37/07-06M 2805 BEECHBANK RD Capitol View Park Historic District transcript:

HISTORIC PRESERVATION COMMISSION STAFF REPORT

Address: 2805 Beechbank Avenue, Silver Spring Meeting Date: 1

PROPOSAL: New House Construction

Beechbank Road Tree Preservation Key

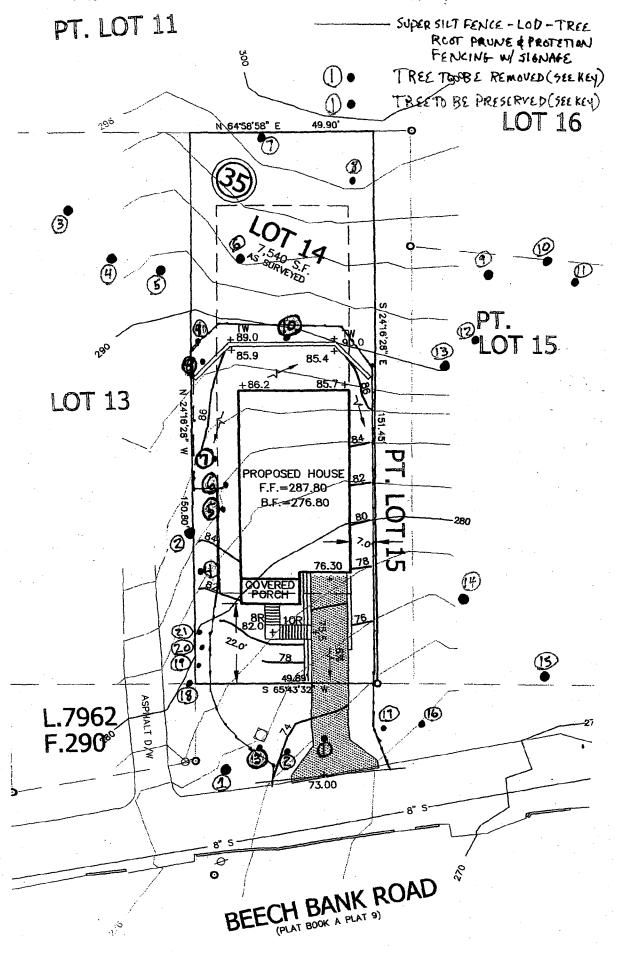
- 5. Additionally, a certified arborist will identify the species, condition and size of all trees 6" and larger on the lot and the adjacent property, which are close to the property line. The tree survey will be used to draft a tree protection plan to help minimize the need to remove, healthy trees. The plan should outline the protection measures that will be implemented to ensure the survival of the trees to be retained during construction.
